U.S. NUCLEAR REGULATORY COMMISSION

Report No. 50-461/92006(DRP)

Facility Name: Clinton Power Station

Inspection from March 17 through April 30, 1992 (Report No. 50-461/92006(DRP))

Figure 1

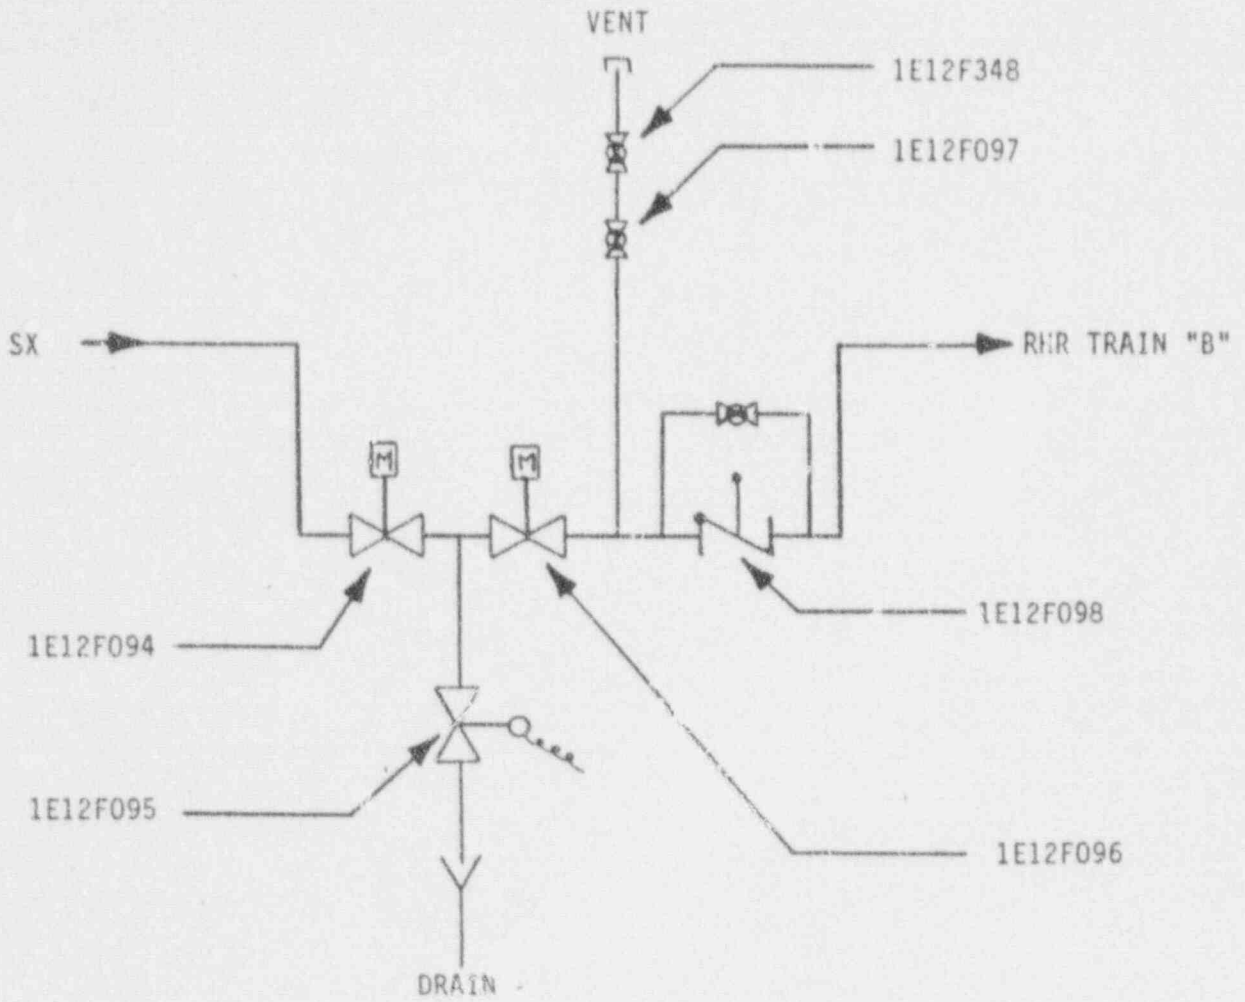
On January 14, 1992, the inspectors identified a concern to the licensee relating to the possible blockage of the flow path through the cross-connect from the shutdown service water system (SX) to the residual heat removal (RHR) "B" train (AMS RIII-92-A-0008). This flow path would allow the licensee to flood the reactor vessel, drywell, and containment with lake water as a last resort, backup, method during a loss-of-coolant accident; and would only be used after multiple failures of redundant safety systems.

between motor operated isolation valves 1E12F094 and 1E12F096 (see figure 1). A functional test of valve F095 was performed as part of the in-service testing (IST) program. This was accomplished by procedure CPS 9053.04, "Residual Heat Removal A/B/C Valve Operability Checks." The drain line was 0.75 inches [1.91 cm] in diameter; while, the main line was 4 inches [10.2 cm] in diameter. The last time that the F095 valve and drain line were demonstrated to function properly was on May 7, 1990. The licensee believed that the drain line was plugged, but that the main flow path was not. Consequently, since the IST procedure could not be followed by observing water draining out of the F095 valve after the F094 and F096 valves were stroked, the F094 and F096 valves were declared inoperable and administratively tagged shut. However, the licensee believed that the main flow path was not blocked and was capable of injecting water into the reactor vessel.

The inspectors asked the licensee if the flow path was considered operable. The licensee stated that this flow path was not required by Technical Specification 3.7.1.1 and that there was no surveillance activity to test its flow capability. The licensee stated it would be very difficult to determine if the main flow path was blocked. Subsequently, the licensee commenced troubleshooting of valve F095 on January 21, 1992, and determined that the solenoid was energized, but that the valve stem was not moving. On January 22, the licensee decided to demonstrate the flow path was not obstructed by injecting cycled condensate water through valve F348 and thence into the RHR system. The flow path from the SX system was then checked by introducing SX water through the F094 and F096 valves and out valve F0348. Mud and silt were found in the line; however, it was not totally obstructed. On February 1 and 2, 1992, the licensee cut out valve F095 and the piping leading to it and replace both with identical equipment.

Subsequently, the licensee decided to radiograph the main flow line during RF-3. The radiograph indicated that the 4 inch [10.2 cm] line was completely filled with silt, except for an approximate 0.75 inch [1.91 cm] channel. The inspectors believed that the channel was created during the flushing in January 1992. The size of the channel equated to the size of the flush path piping leading to the F0348 valve. The results of the radiograph indicating a potential "silt trap" in the piping. Therefore, the licensee's engineering department developed a design modification to install a 2.5 inch [6.4 cm] flushing connection between valves F094 and F096. The modification was scheduled to be installed before the end of RF-3.

Technical Specification 3.7.1.1.b required that the SX loops shall be operable in Operational Conditions 1 through 5. Each operable shutdown service water loop shall be comprised of . . . an operable flow path capable of taking suction from the ultimate heat sink and transferring water through the associated systems and components that were required to be operable. The Clinton updated safety analysis report (USAR), section 9.2.1.2.1.1.c., defined one of the design purposes of the shutdown service water system as flooding the drywell and containment (via the reactor vessel) through the use of RHR piping, if required following a postulated loss-of-coolant accident. Consequently, the inspectors believed that this flow path was required to be operable.

Further review of the safety significance of this issue and the timeliness of the licensee's identification and corrective actions will be reviewed in a subsequent report and will be tracked as Unresolved Item (461/92006-01(DRP)).
